| Applicant: Solare Collegiate Foundation  |   | Phone:   |
| Subdivision/Addition: El Rancho Grande I   | MRGCD Map No.:                                | UPC Code: 100905533402040127 (Tract 12-B-1-A)<br>100905538202740125 (Tract 12-B-1-B) |
| PR-2019-002042; PS-2021-00121; PS-2022-00003   |   |  |

Preliminary Plat for  
Sombre Del Oeste  
Being Comprised of  
Tracts 12-B-1-A and 12-B-1-B  
El Rancho Grande I  
City of Albuquerque  
Bernalillo County, New Mexico  
February 2022

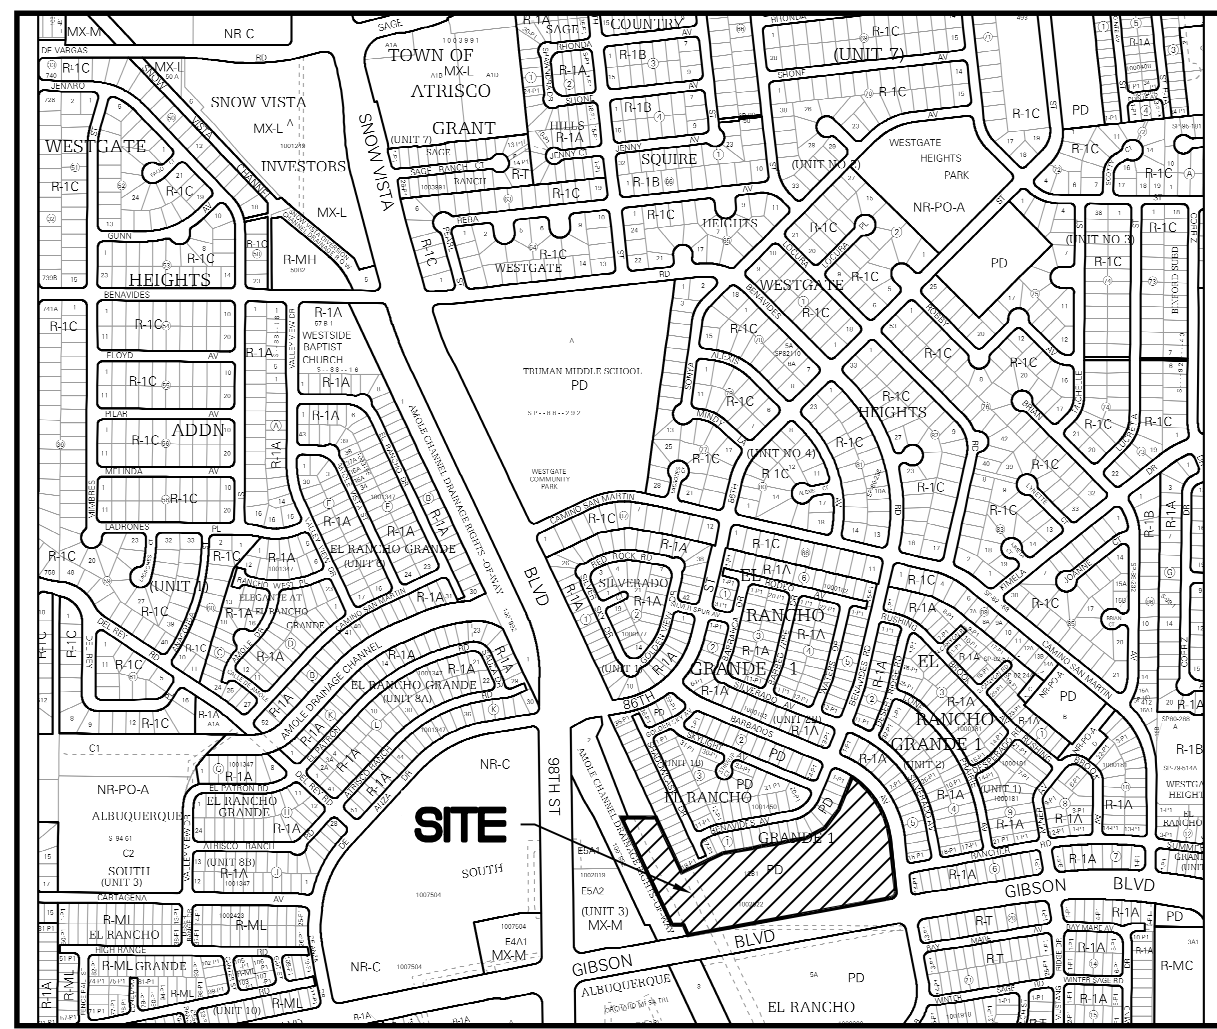
- Keyed note 4 shows a 10 foot wide pedestrian easement, but there appears to be a solid wall across the easement. Will a gate or similar be added?  
**This keyed note is related to the developed properties to the north of this plat. The 10-foot pedestrian access easement was developed and is currently walled off with no access gate and located on private property.**

| <b>FOR OFFICIAL USE ONLY</b>     |   |      |              |            |      |

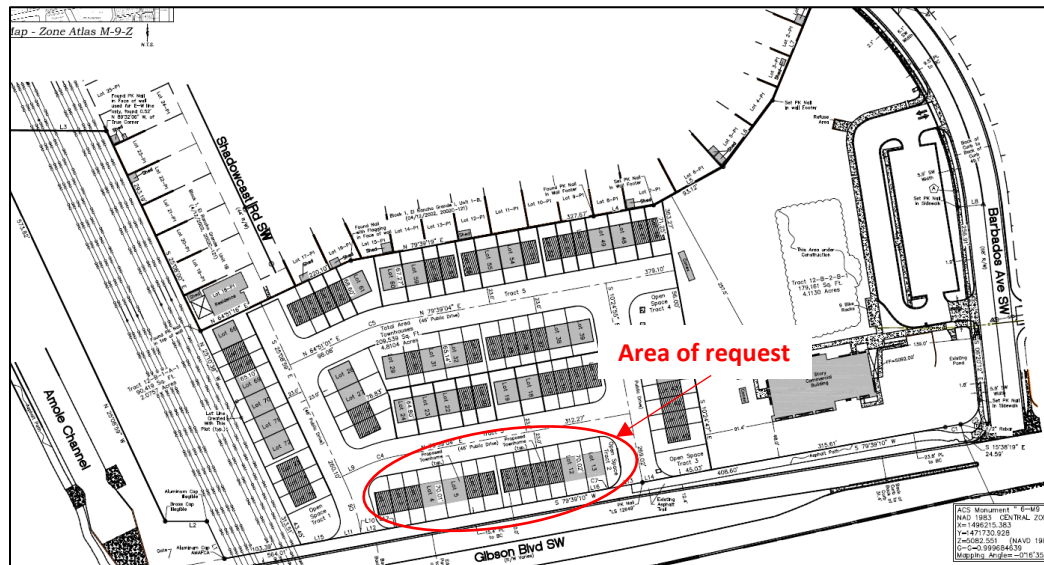
| <b>Printed Name:</b> Denise King | <input type="checkbox"/> Applicant or <input checked="" type="checkbox"/> Agent |      |              |            |      |
